Development Review Board

Tuesday, December 19, 2023, 5:00 PM

ZAP-23-12; 123 King Street (RH, Ward 5) Rebecca Keinath / Charles Keinath

ZP-23-530; 0 University Road (I, Ward 1) University of Vermont / State Agricultural College / Claire Forbes

Front of House (North)

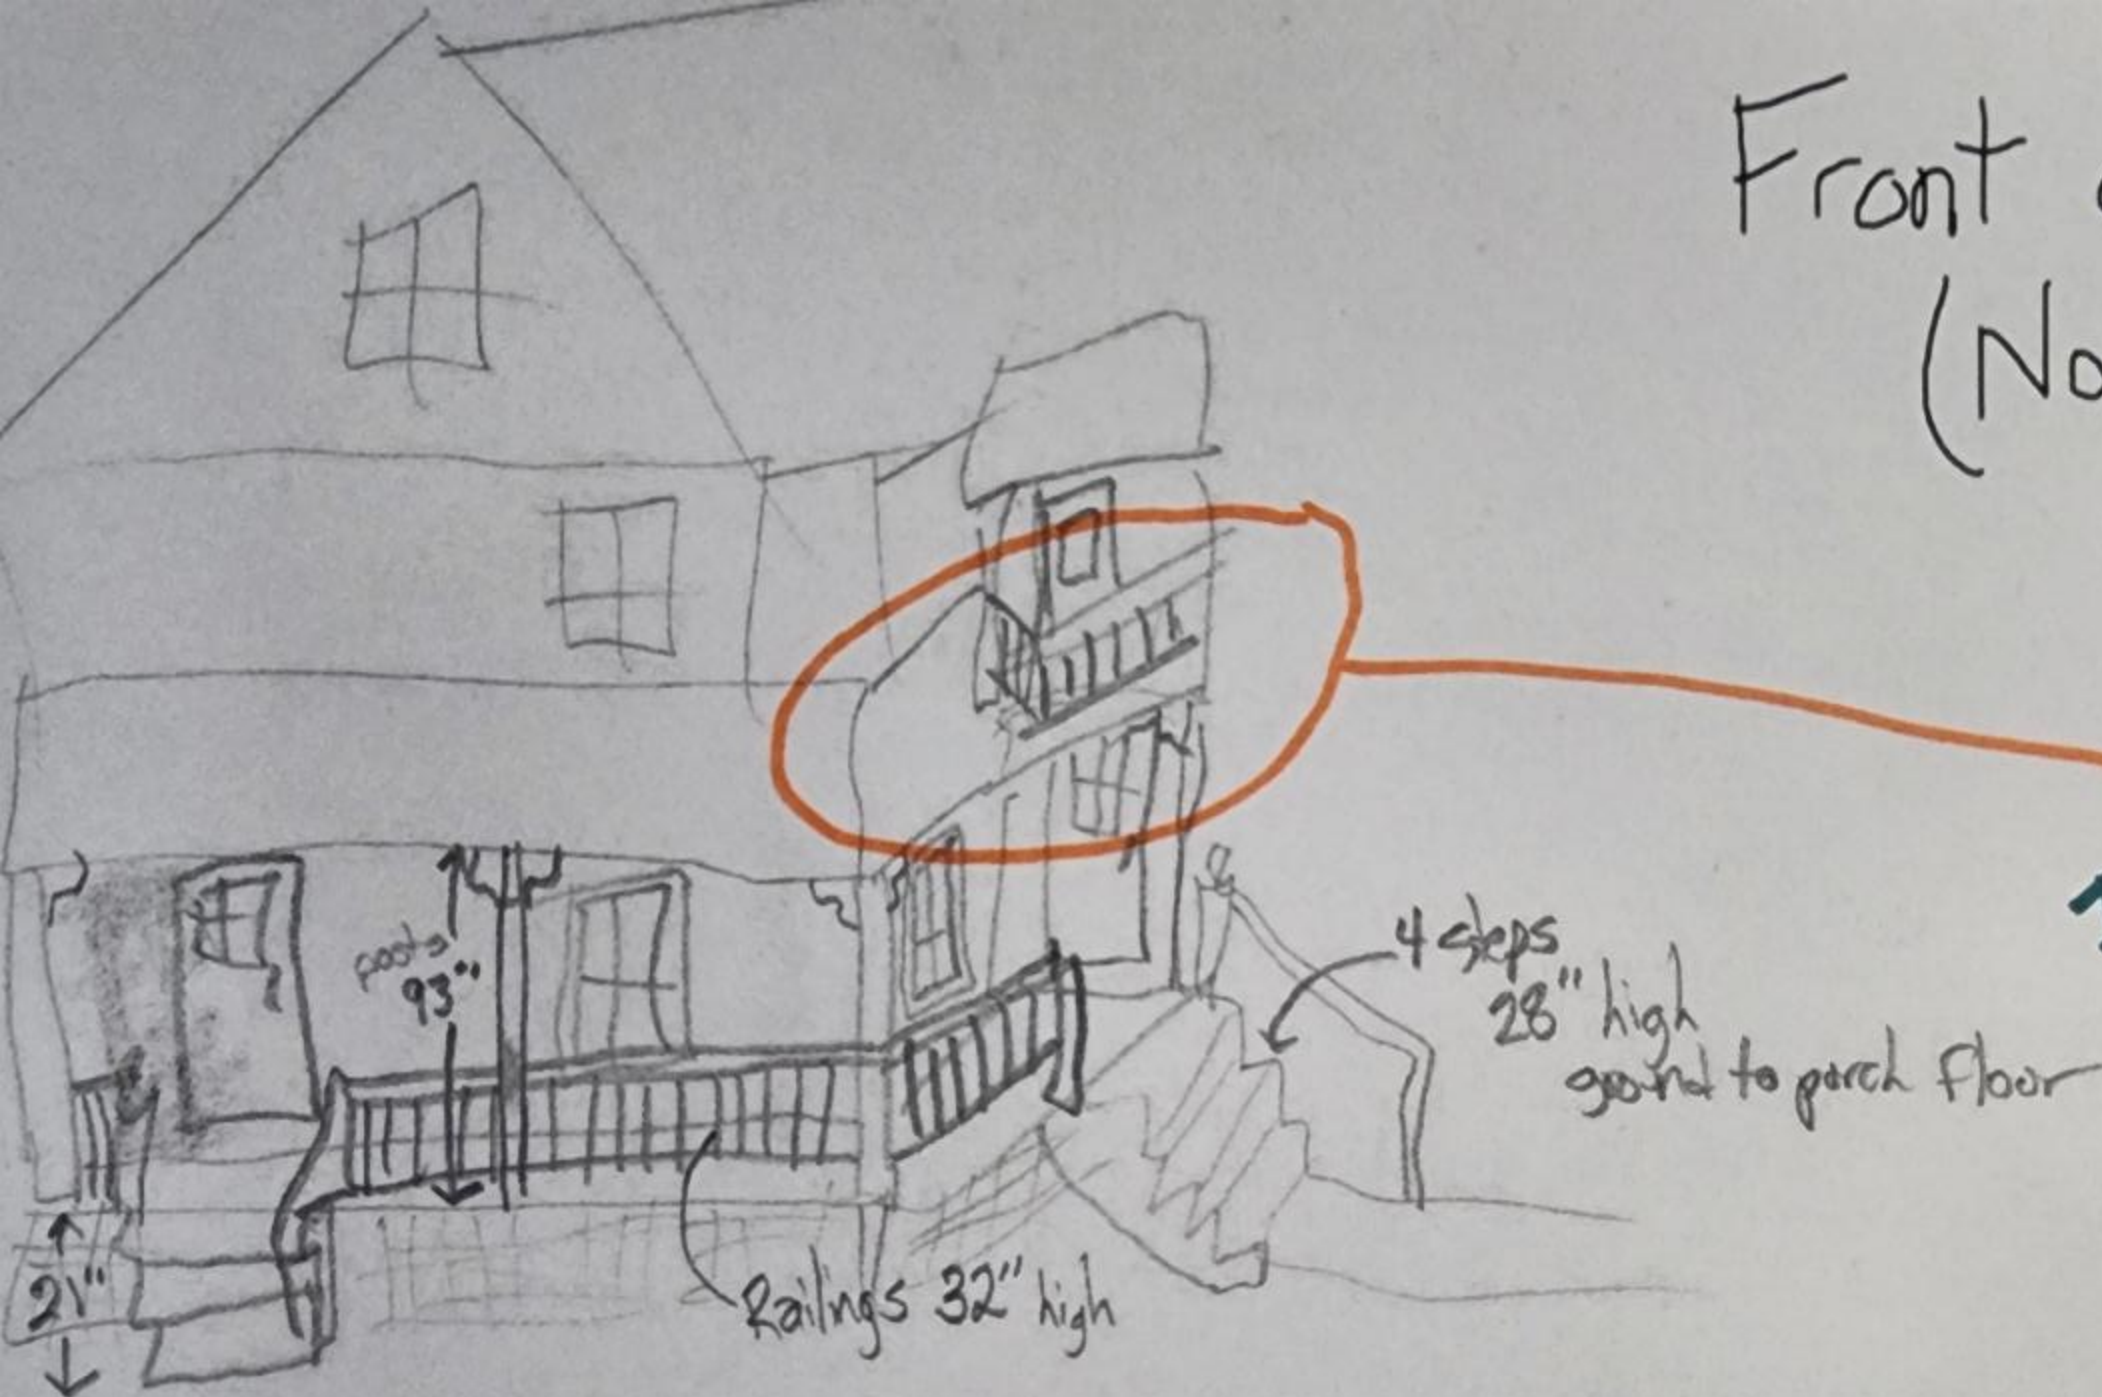
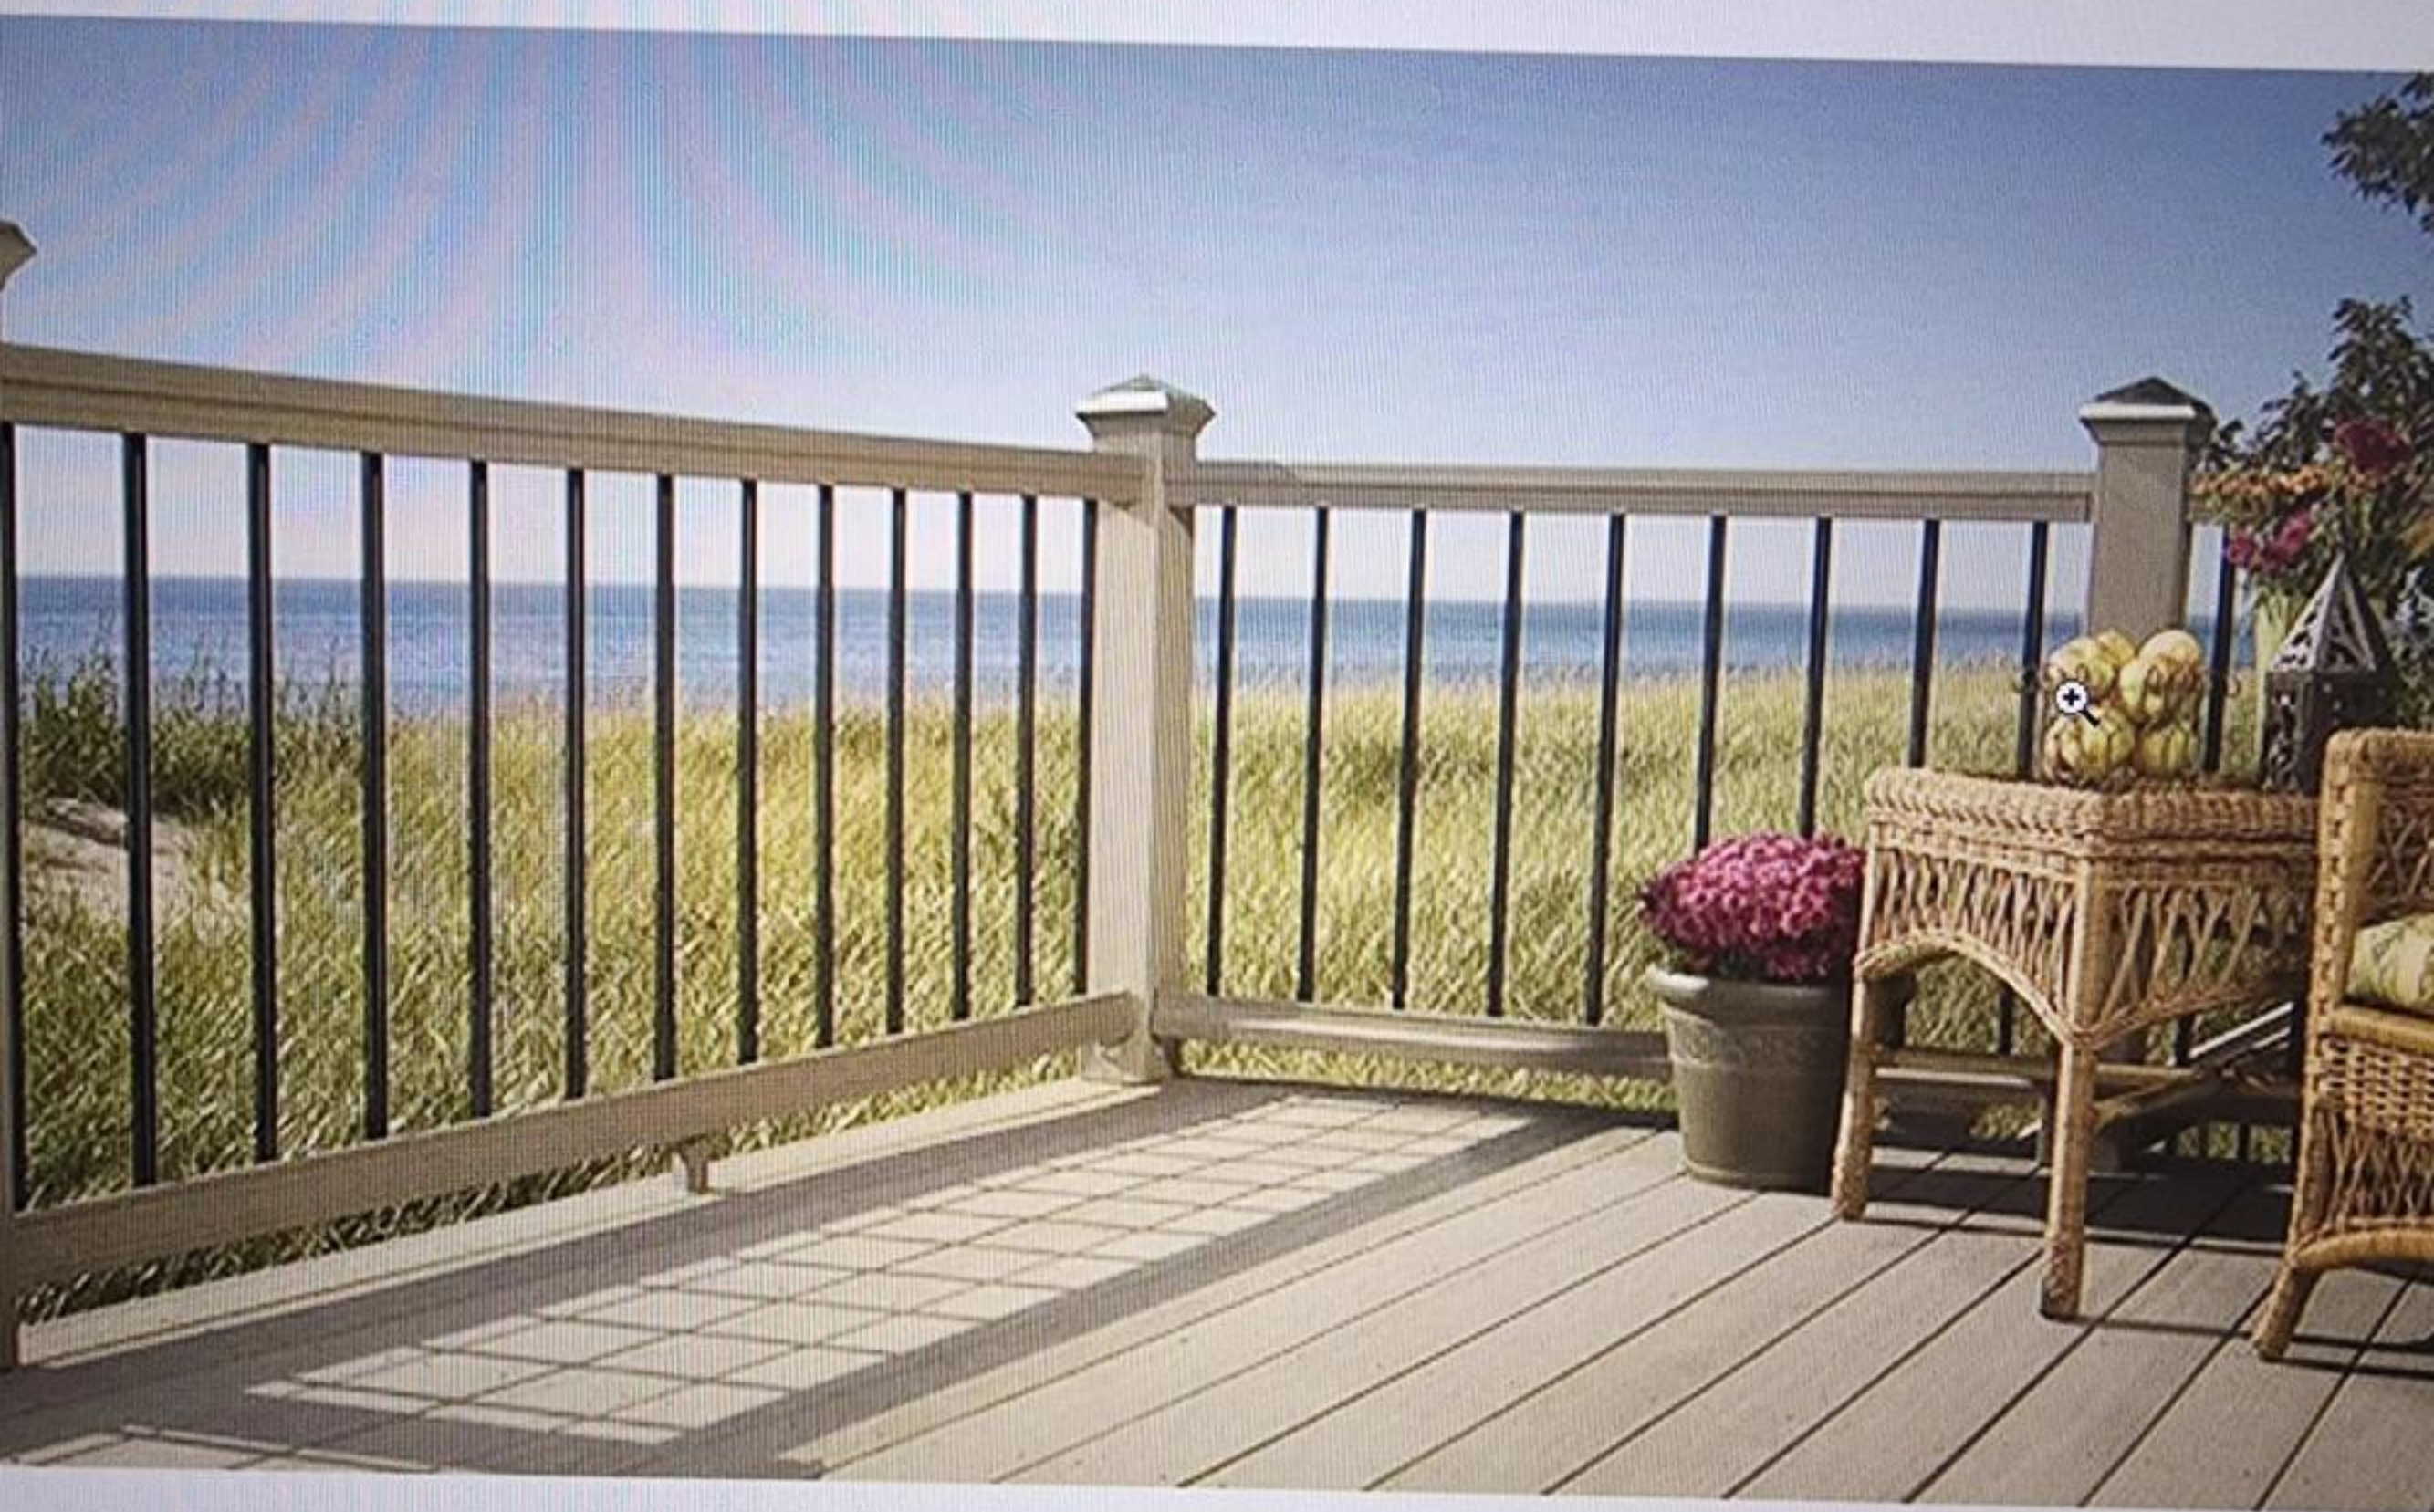
This is the section
I am requesting to
change.

Assessor's photo

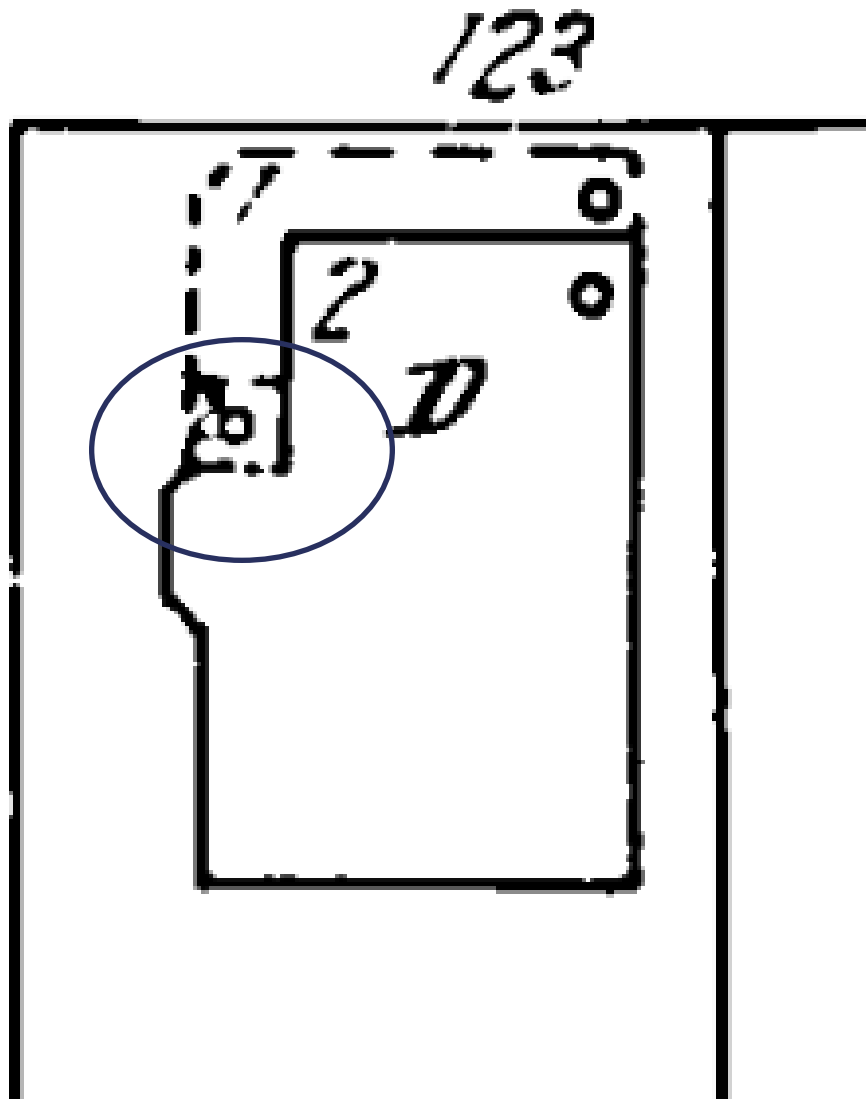
The appeal asserts that the present configuration of the 1-bay, 2nd story porch under the eaves is not original and that it extended further along the 2nd story. The appellant states that structure underneath the exterior suggests this was the case. However, both the 1977 photo of the building when it was surveyed for historic significance and the recent city assessor's photo of the building show it in its present configuration. (Note that the assessor's photo does not show the recently permitted 1st story full-width front porch. That feature was removed some time ago and has been permitted for replacement based on documentary evidence.) The 1942-1950 Sanborn map also shows the 2nd story porch in its present configuration. Documentary evidence clearly points to a 1-bay porch tucked under the eaves on the side. Similarly, documentary evidence supported the historic existence of a full-width open front porch on the 1st story. Subsection (b) 3 of Sec. 5.4.8 notes that addition of conjectural features will not be undertaken.
